ADDENDUM

No. 04 **Date:** 9/18/2024
Project No. 0020711.01 **Attention:** Leonard D'Souza
Project Name: Princess Margaret Cancer Centre
Stem Cell Transplant 2, MHC, MHDU, DSC
Address: University Health Network
610 University Avenue
Toronto ON

1 LEVEL 05 - RAMPS & DECKS FRAMING PLAN
1:100

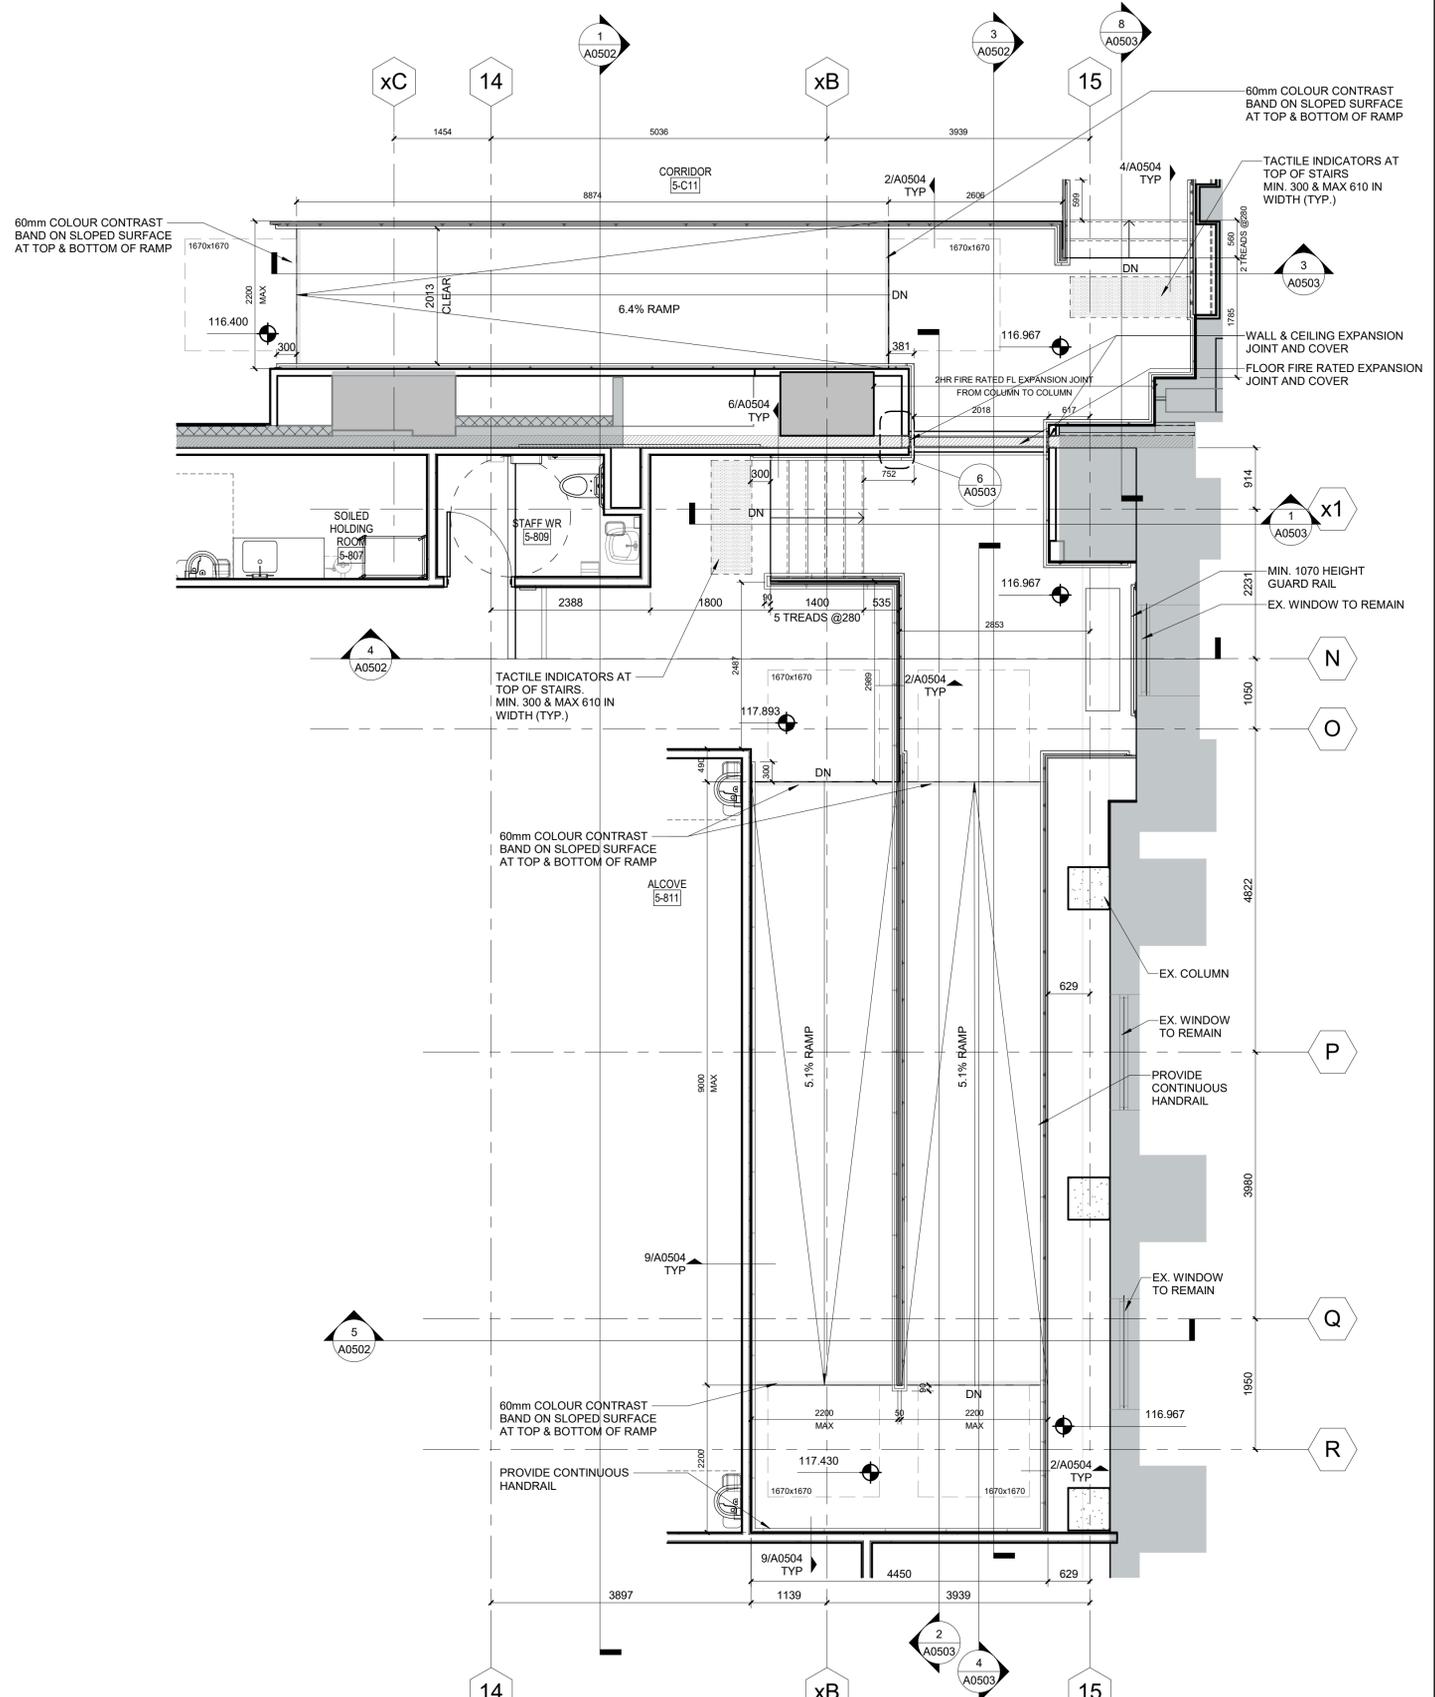
56. (426) Some structural channels are shown below the megaboard floor attached to structural studs posts. Is it under the scope of the miscellaneous? Refer detail 7/A0503. Even though the channel refers to structural drawings nothing is shown in the structural drawings. Can you please provide some inputs? Also the Guardrails in 2/A0504 shown as sitting on Misc. Channels Question is if by Misc. Metals, whether these channels need to be spread on the entire floor as shown in 1/A0501 and what type of connection?

Response: Glass guardrails at floor and ramp edges are supported HSS10x2x1/4 (51x254mm) as shown in the detail 2/A0504 and the HSS tube locations have been specified in the detail 1/A0501. Engineered shop drawings submittal to include glass guard rails.

Response: Refer to Detail 2 on A0501

13 TYPICAL EXPANSION JOINT AT COLUMN
1: 20

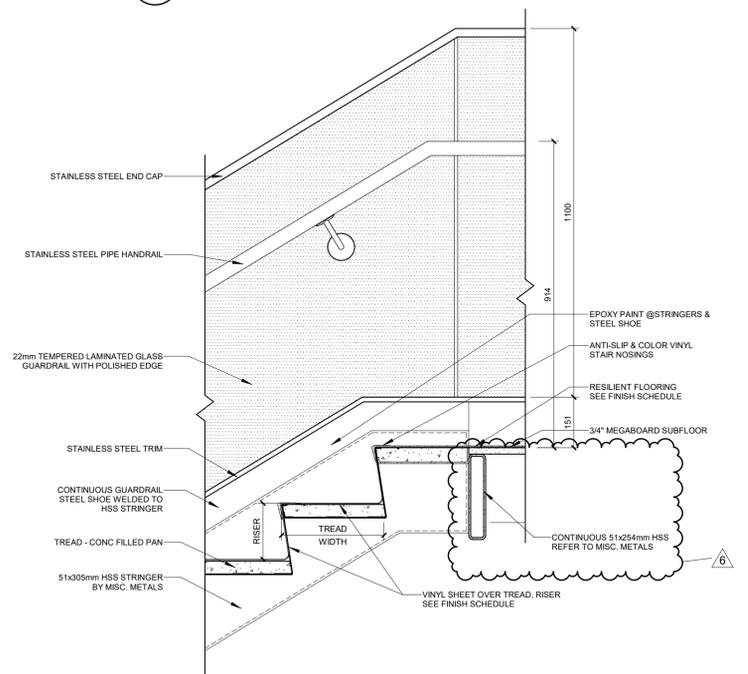
18. (254) Drawing A0504 shows two sections 13 and 14, mentioning Typical expansion joint on columns and at doors.

2 GUARDRAIL DETAIL AT MEGABOARD DECK
1: 10

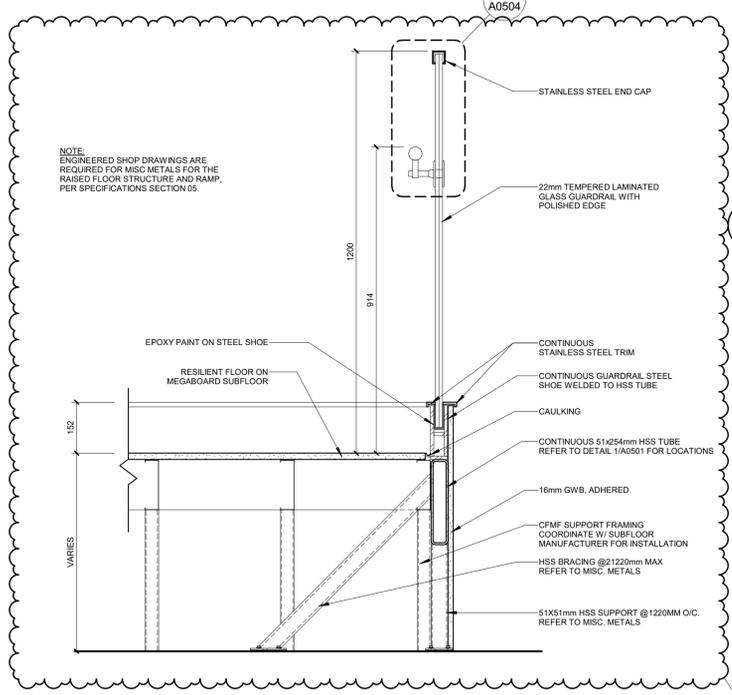
48. (414) (Dwg A0504, S0002) Dwg A0504 detail 1 & 5 show Steel Channel (by Misc. Metal trade) attached to Structural stud framing (by drywall trade). The structural dwg S0002 details A, B, C &D do not show any Misc. Metal support. Please confirm the provided details are correct and if steel channel are required, please provide the size and detail.

1 SPANDREL WINDOW DETAIL
1: 25

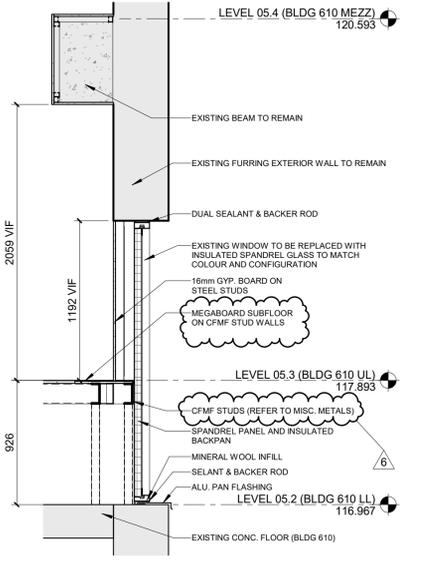
47. (413) (Dwg A0504, A0501, S0002.) Dwg A0504 detail 1 & 5 show Steel Channel (by Misc. Metal trade) sitting on Structural stud support (by drywall trade) to support Mega board Sub floor. The structural dwg S0002 details A, B, C & D do not show any Misc. Metal support. Please confirm the provided detail is correct. Ramps & deck framing plan, detail 1 on dwg A0501 shows, rows of steel stud wall attached together. If the Miscellaneous metal framing required above the stud wall, please provide a detailed layout and the steel member size.

Response: Megaboard floor is supported by CFMF studs. Details 1&5/A0504 have been updated accordingly.

- b) Is the BAS Contractor responsible for the AH-033 Control panel
- c) Can the BAS Contractor carry the cost and coordination of the Control items, including damper actuators for the AHU Unit Mounted and other duct mounted Dampers, Valves ect. to have consistency throughout the project.

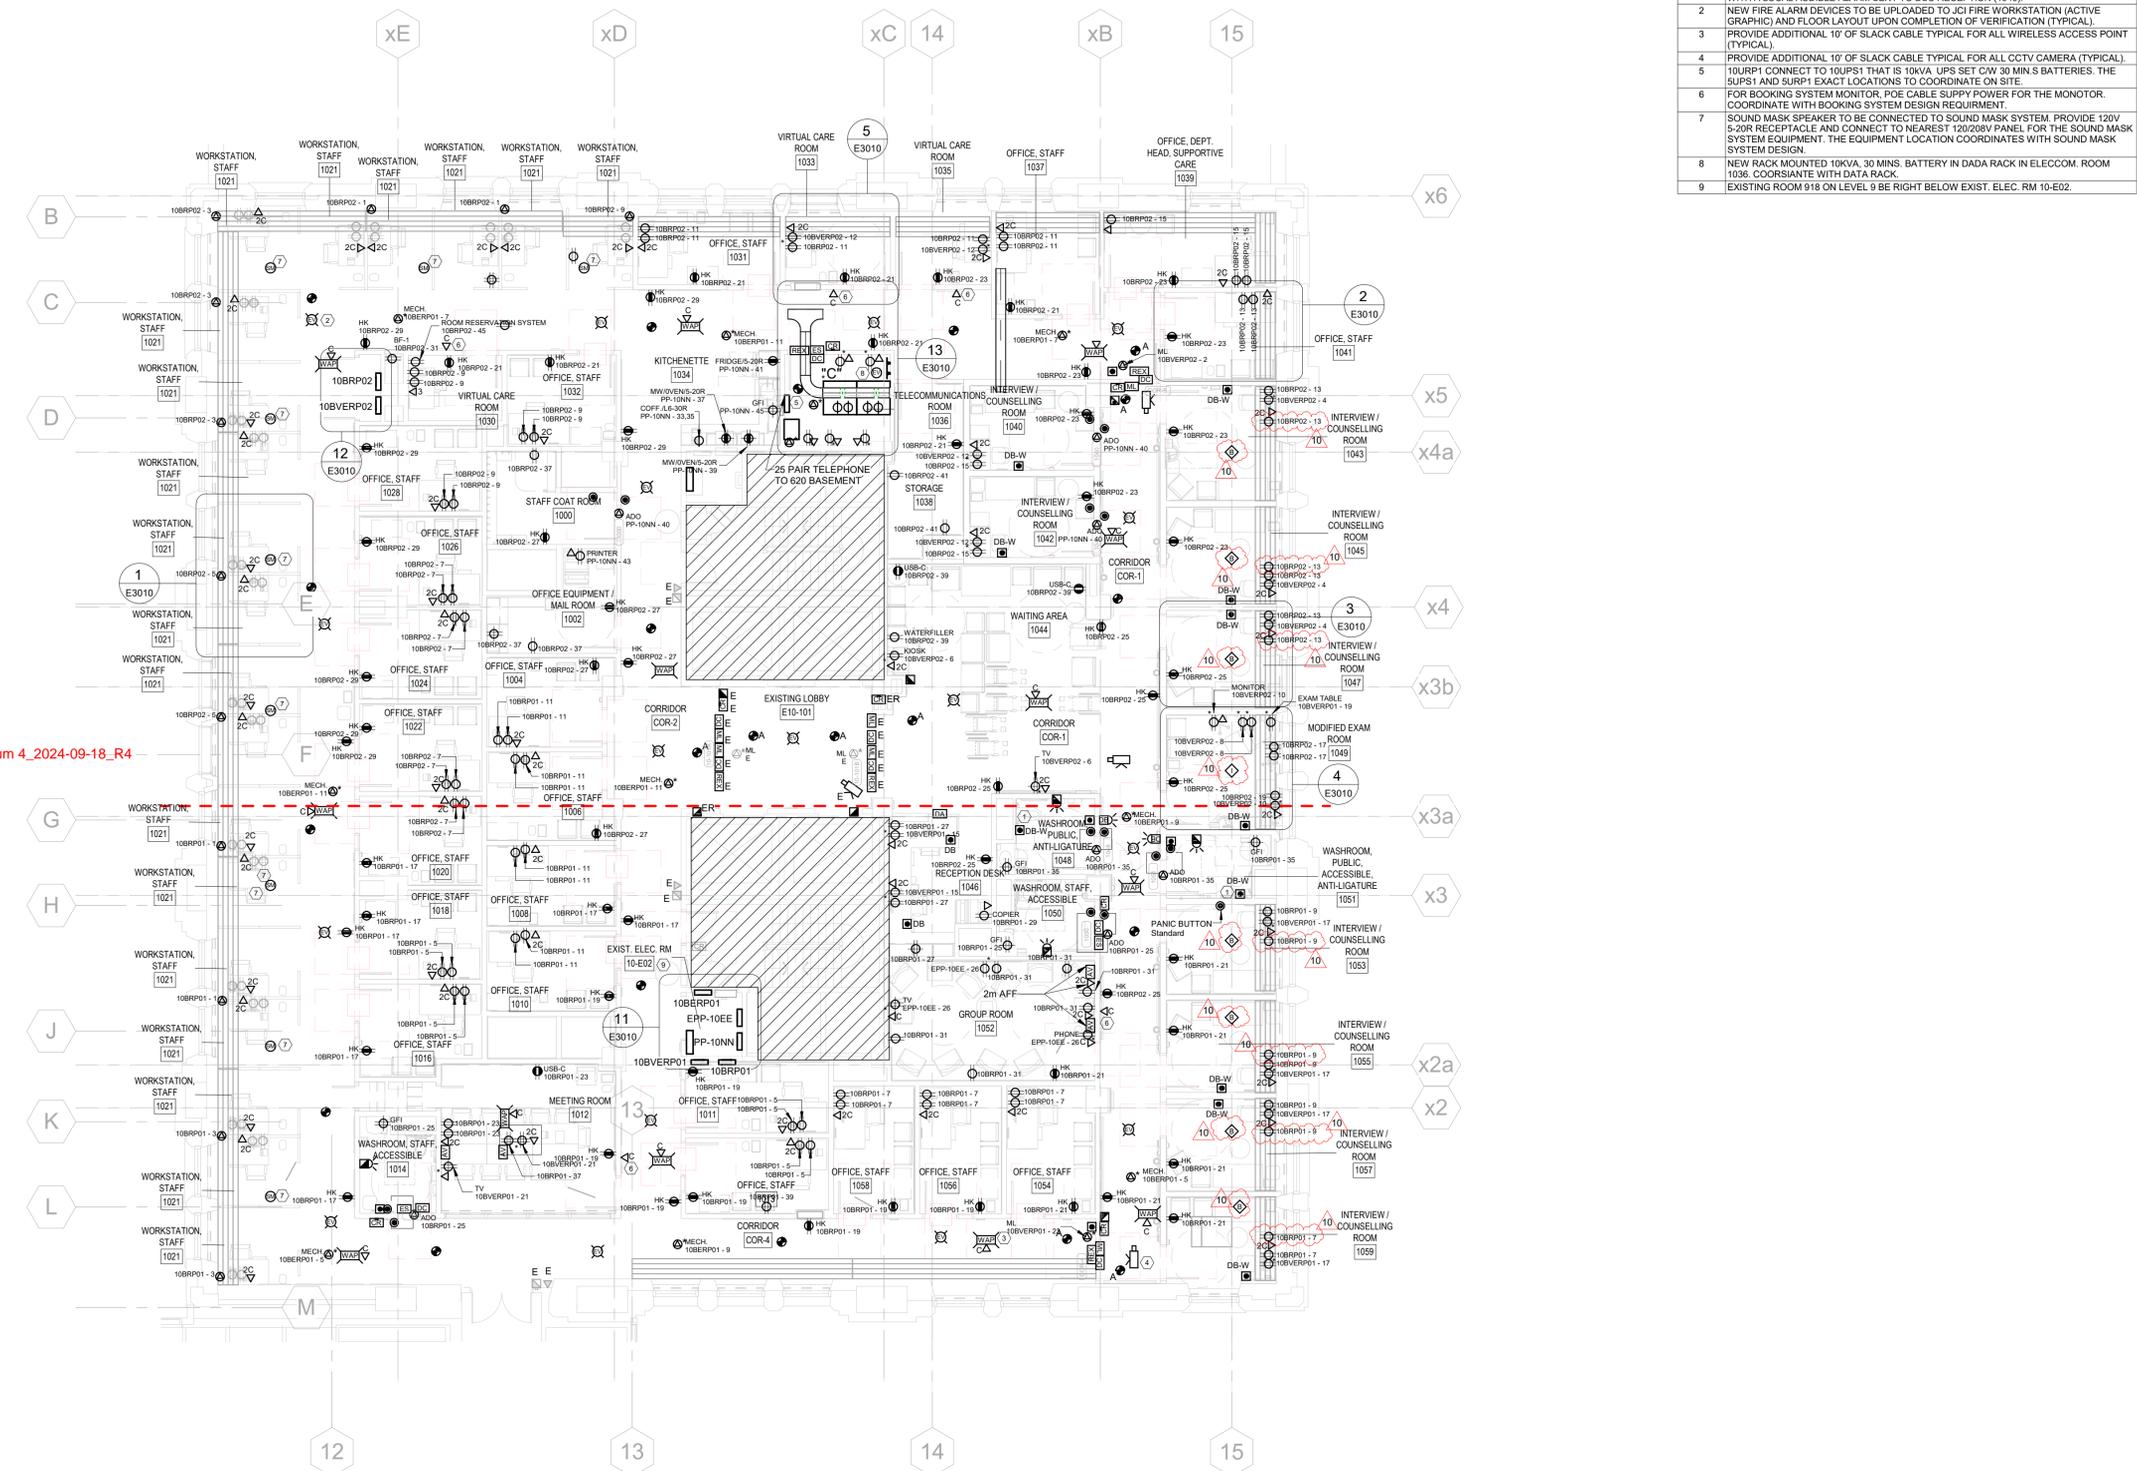
On Drawing E2110 Level 10 there are 9 SM- devices shown and Note 7 specified it will be connected to Sound Masking System. There is no Spec. 27-51-19 & riser in the specification/drawing for it. Please provide the details for the same. Additionally, please specify if there any Base building contractor for it?
